CITY OF PORTLAND
APPROVED SITE PLAN
Subject to Dept. Conditions
Date of Approval: 9/22/05

Site Plan
11 Bryant Street
Portland, ME

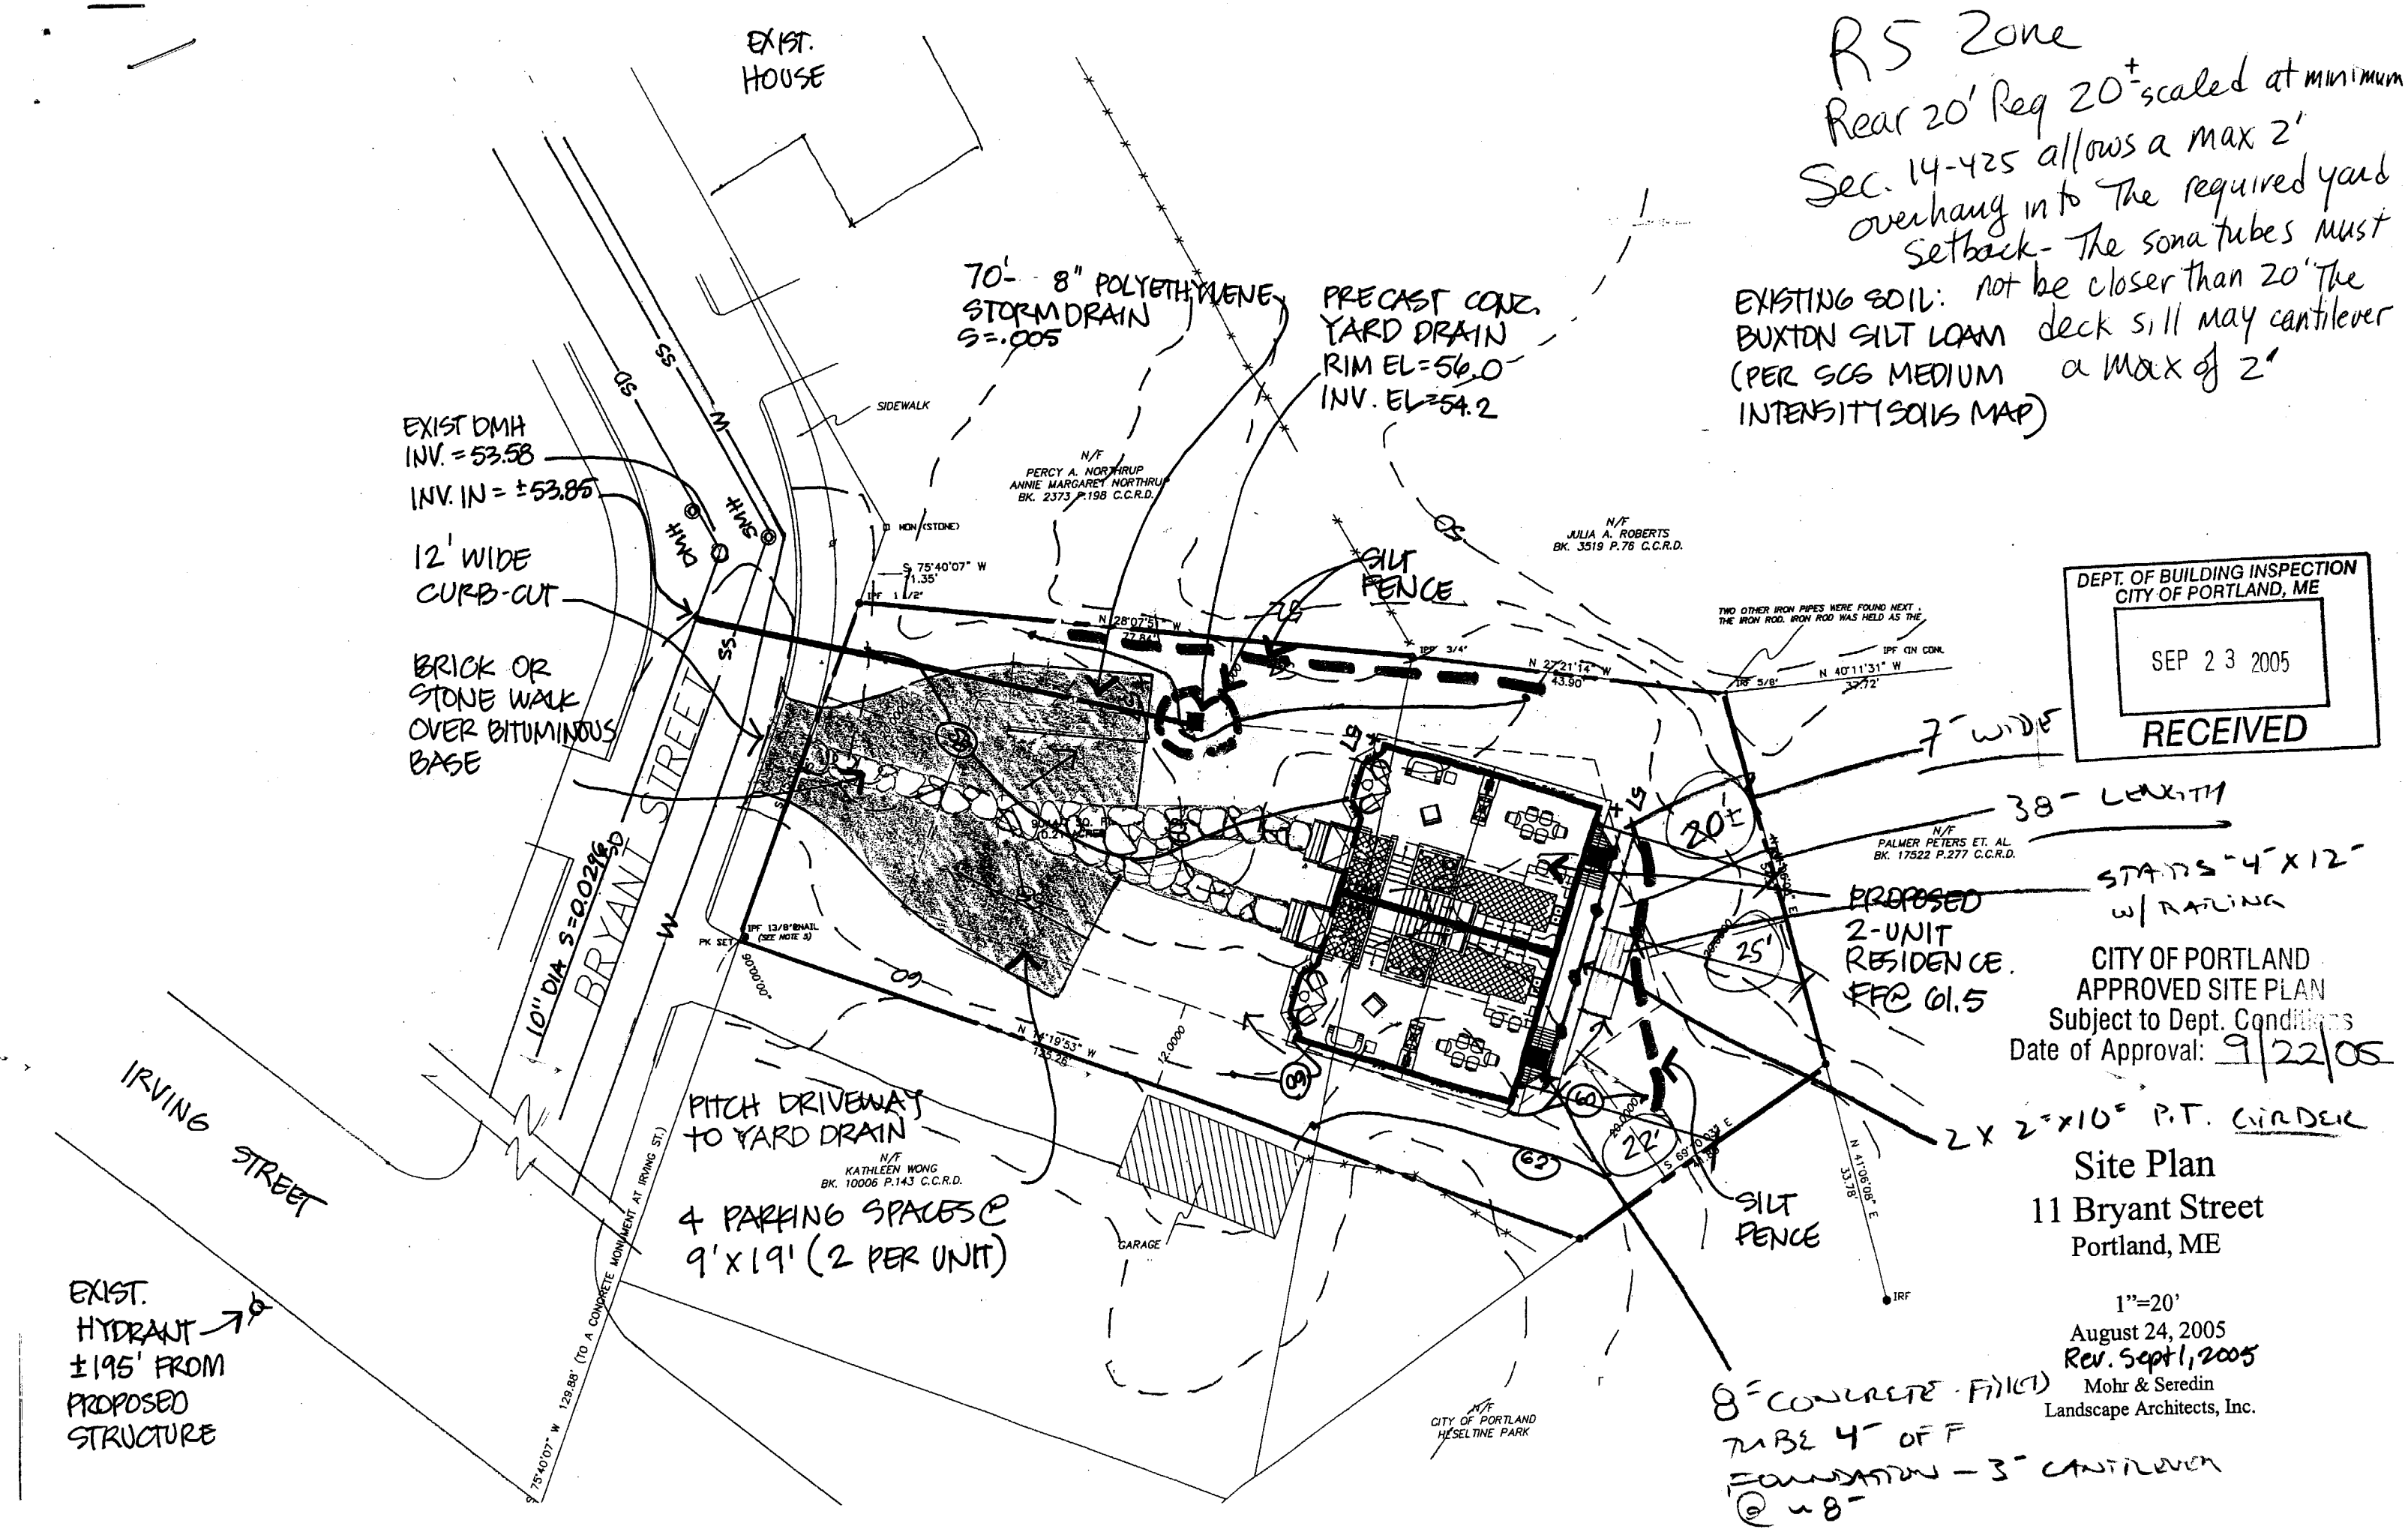
RS Zone
Rear 20' Req 20± scaled at minimum
Sec. 14-425 allows a max 2' overhang into the required yard setback - The sona tubes must not be closer than 20' The deck sill may cantilever a max of 2'
